Council Meeting - Agenda Item 9.1 - Attachment 4 - Representations - 21 October 2021

From: "Louise Johnson" [REDACTED]
Sent: Mon, 27 Sep 2021 20:29:03 +1000
To: "Contact Us" <contactus@launceston.tas.gov.au>
Subject: Solar panel report, DA 0416-2021
Attachments: Solar panel report September 2021 (for DA 0416-2021).docx

Report submitted on DA 0416/2021

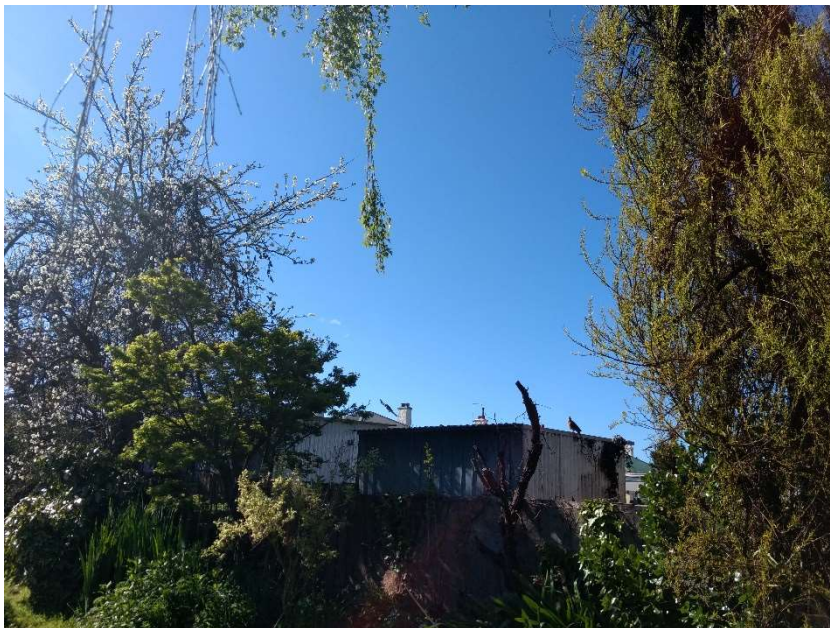
Overlay of SW wall of new 2-storey dwelling as it will be viewed from the outdoor living area and workshop/stable of 25 Lytton. Early morning sun will be lost. The planned building will cause hours of overshadowing on 25 Lytton St.

Elevations & perspectives

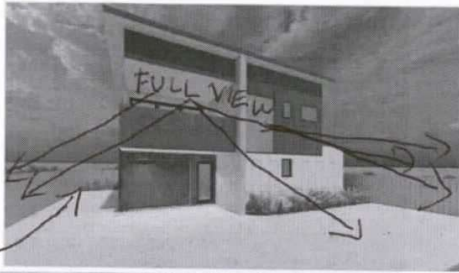
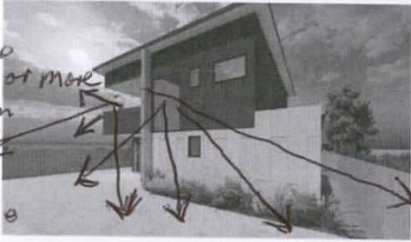
Forgot to draw in the car(s)

Nice 180° or more view from balcony - make that 225° view from balcony.

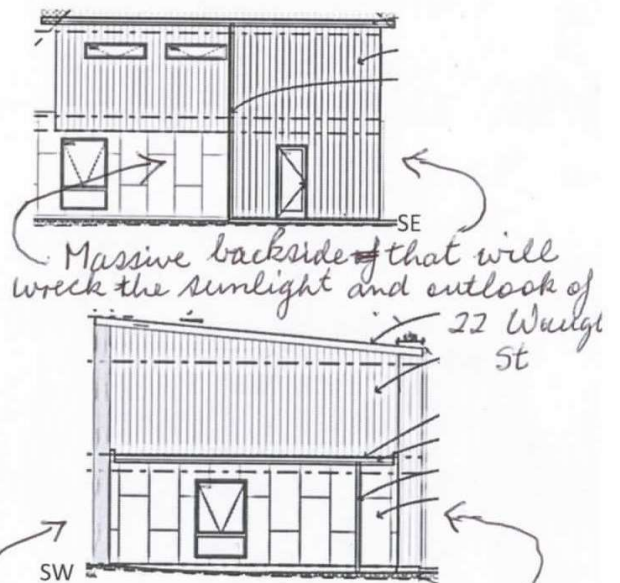
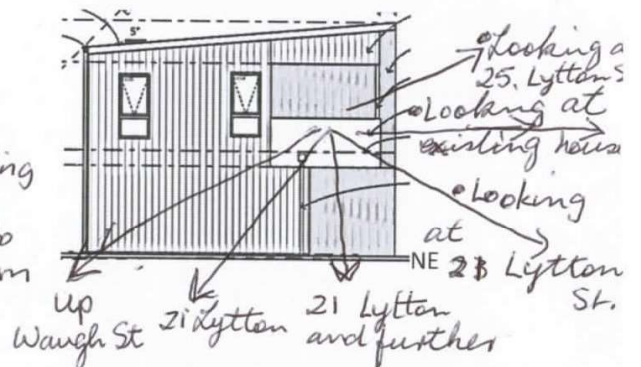
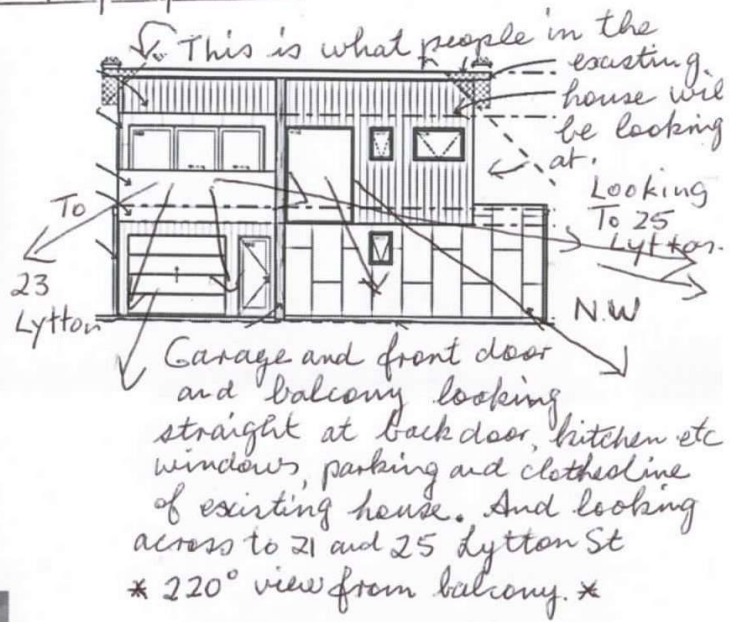
Main bedroom one metre from other house's car park

Two cars missing from car park to main bedroom

Is this in the middle of an open field or maybe a golf course? No other houses to be seen.

PARKING without cars.

Original Design (see next page for New Magic Creative Design)

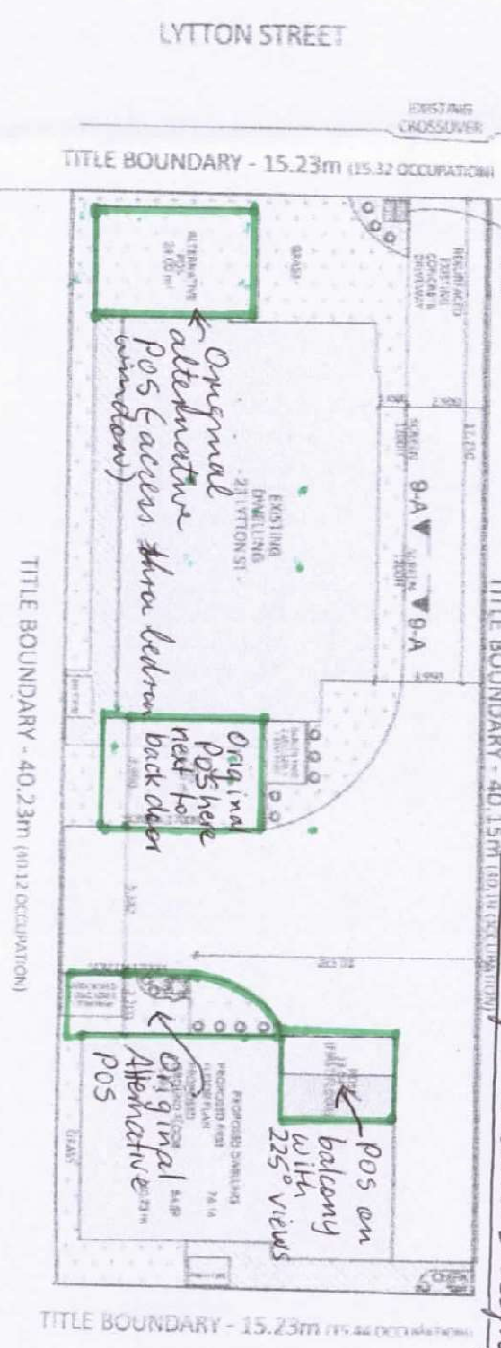
How to change a landscape plan to make more space - like magic - to trick the Council into approving a DA like this one.

Some houses, same everything, just move the 2-storey thing and do some creative colouring in and magic words for the private open space.

How to make Private Open Space bigger for the purposes of a DA:- Change the main space by changing it to 'Primary' POS and colour in a larger area - i.e. stretch it out to the fence, include paths, washing line area to make it look really big. Do the same with the Alternative Private Open Space. Don't concern yourself with incidents such as sitting numerous activities (outdoor dining and washing lines are very compatible). Teach the children and the pets to sit still, so that they and the adults can all enjoy the POS.

New Magical Creative Design for Landscape Design

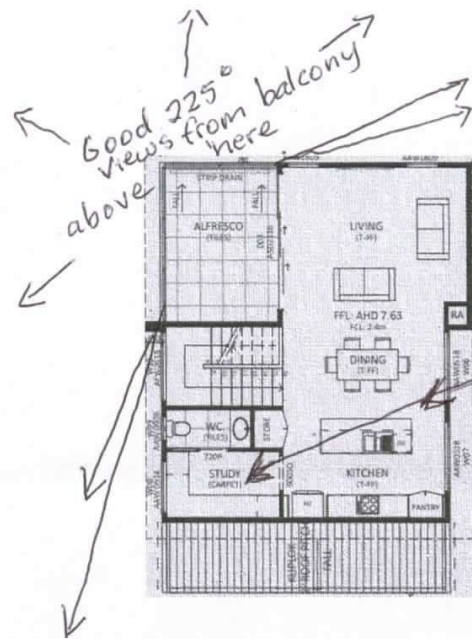
If POS not big enough for everything that the design plan claims, there's always the footpath and gutter for children's play
